PROJECT TITLE: Sandia Laboratory Federal Credit Union Addition ZONE MAP/DRG. FILE # - G-21/DD27-
DRB#: N/A EPC#: N/A WORK ORDER#: N/A

Re: Sandia Laboratory Federal Credit Union Addition
SEC Project #111118

**Re: Sandia Laboratory Federal Credit Union Addition, Grading and Drainage
Plan, 3700 Juan Tabo Blvd. NE, Engineer's Stamp dated 9-12-11
(G21/D027)**

FIGURE 3

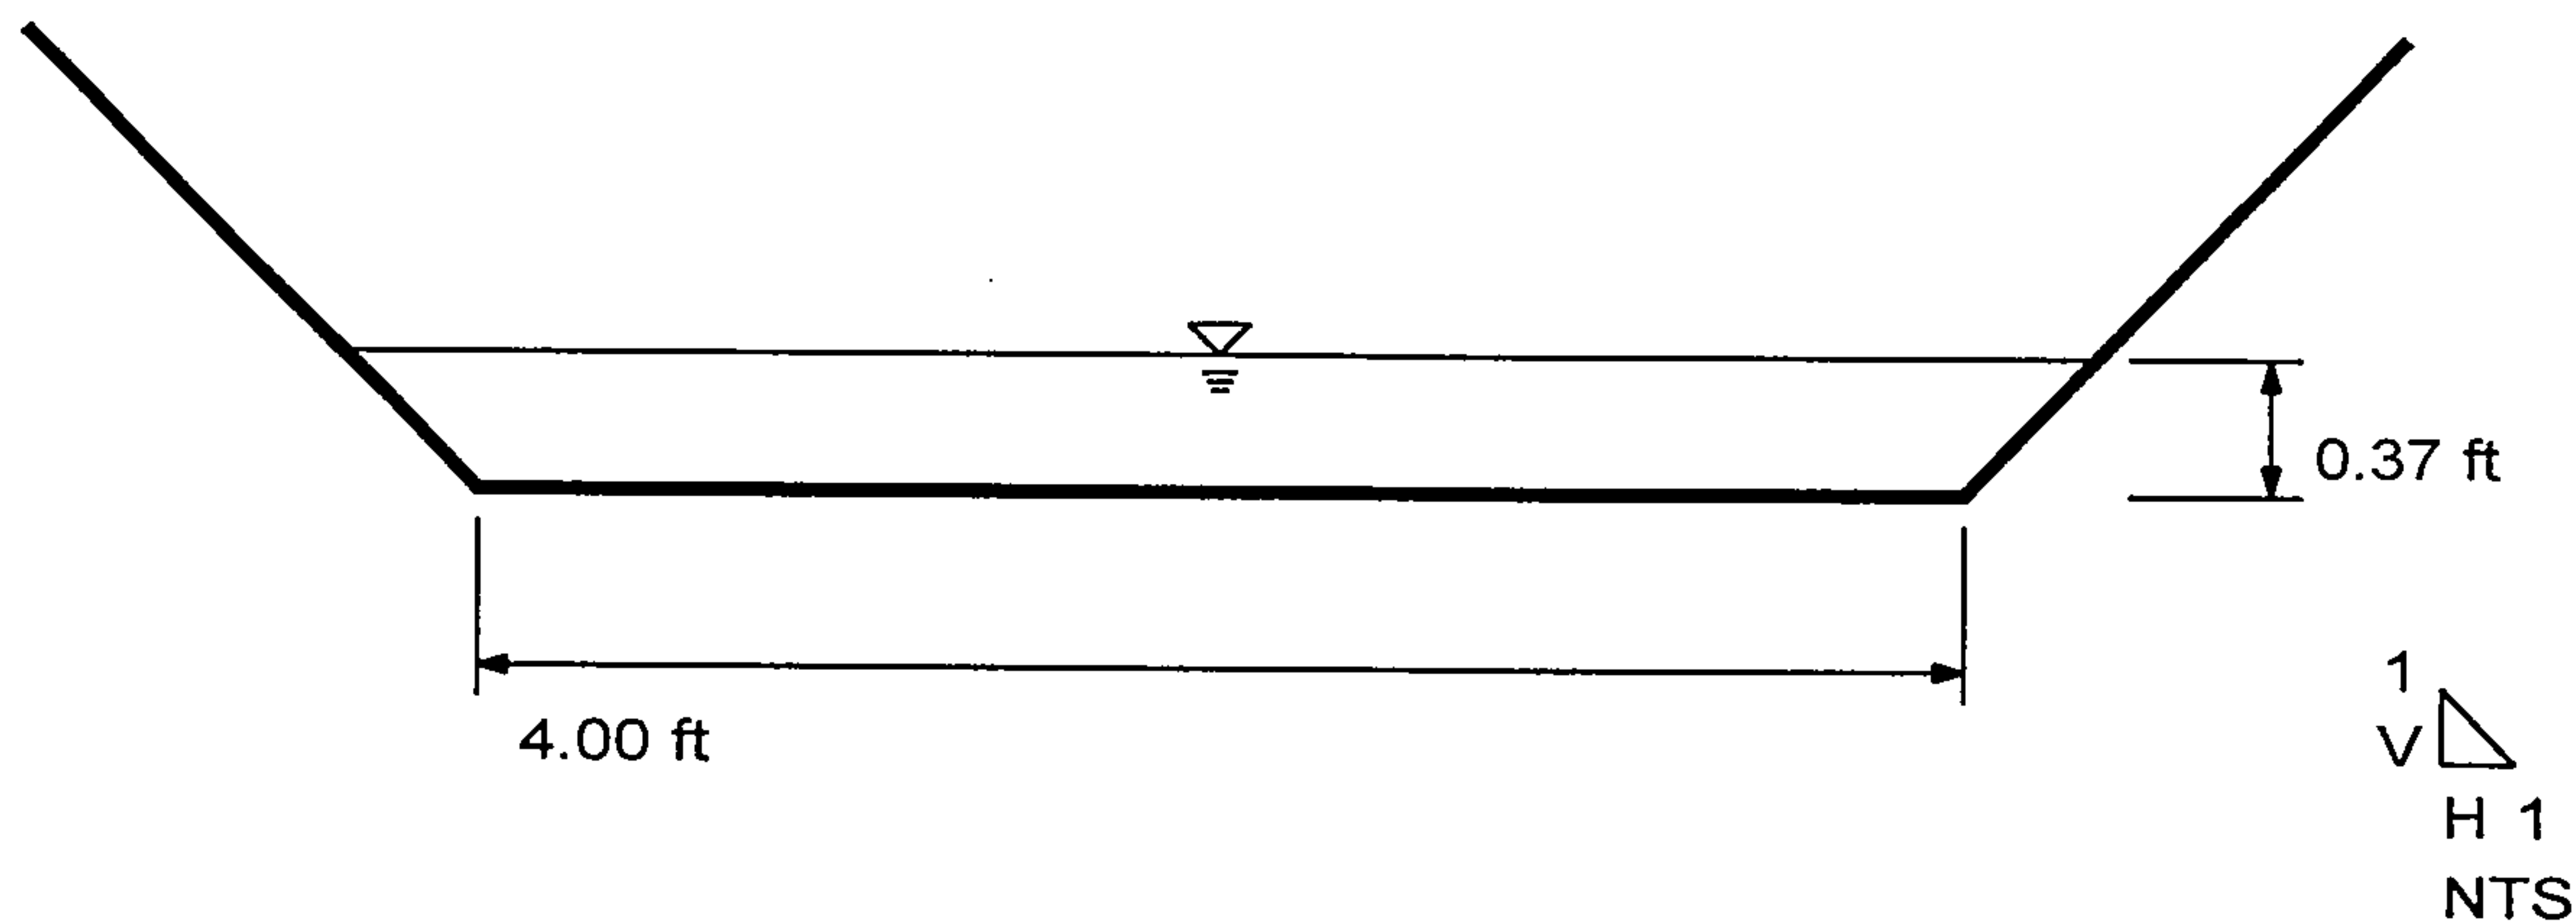
Figure 3 shows that a 4' wide concrete channel with 1:1 side slopes will flow only 0.37 (2 1/2") feet deep when the 100 year storm event (8.6 cfs) occurs. The proposed rundown channel will have the same total depth as the onsite standard curbing, which is 8".

FIGURE 3

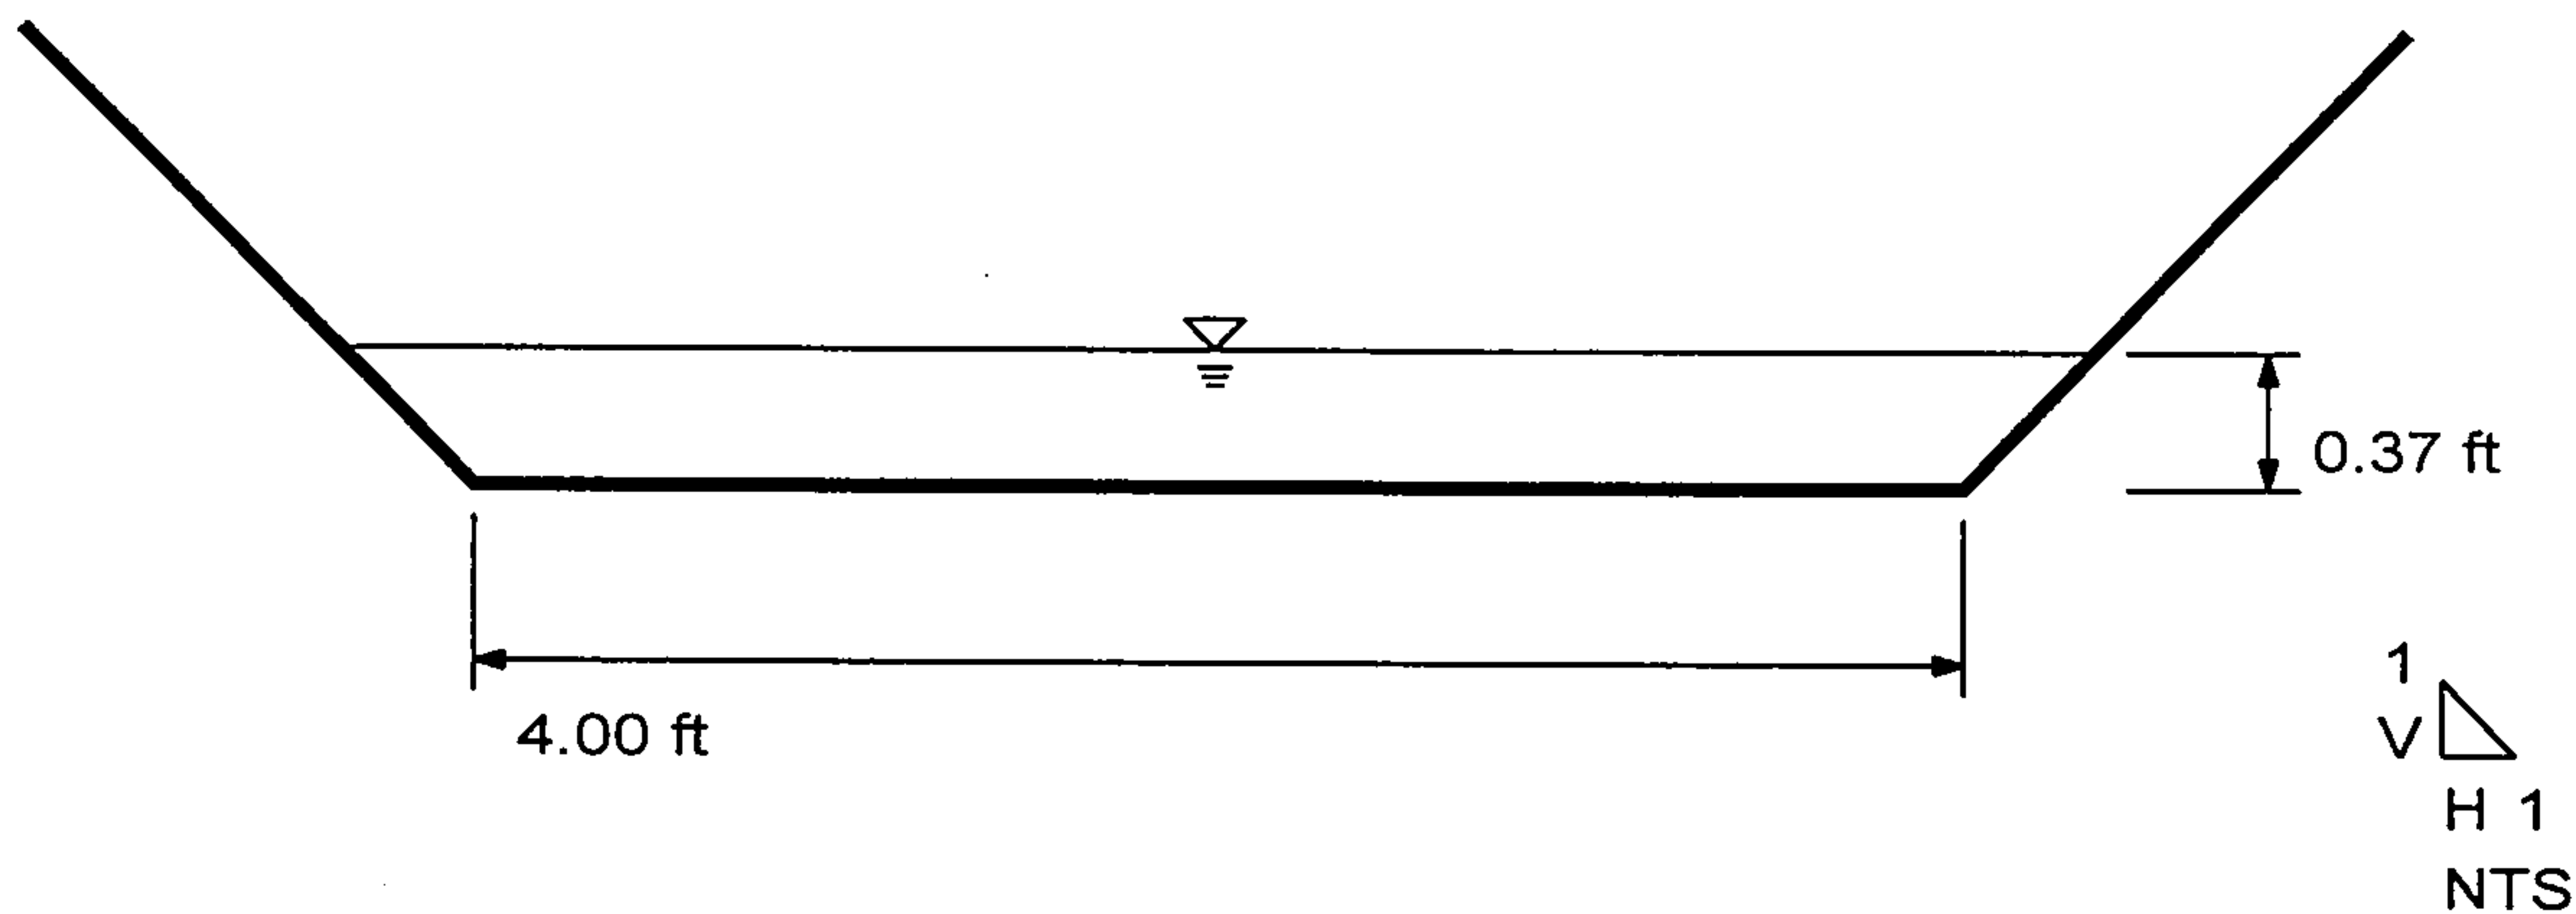
Figure 3 shows that a 4' wide concrete channel with 1:1 side slopes will flow only 0.37 feet deep when the 100 year storm event (8.6 cfs) occurs. The proposed rundown channel will have the same total depth as the onsite standard curbing, which is 8".
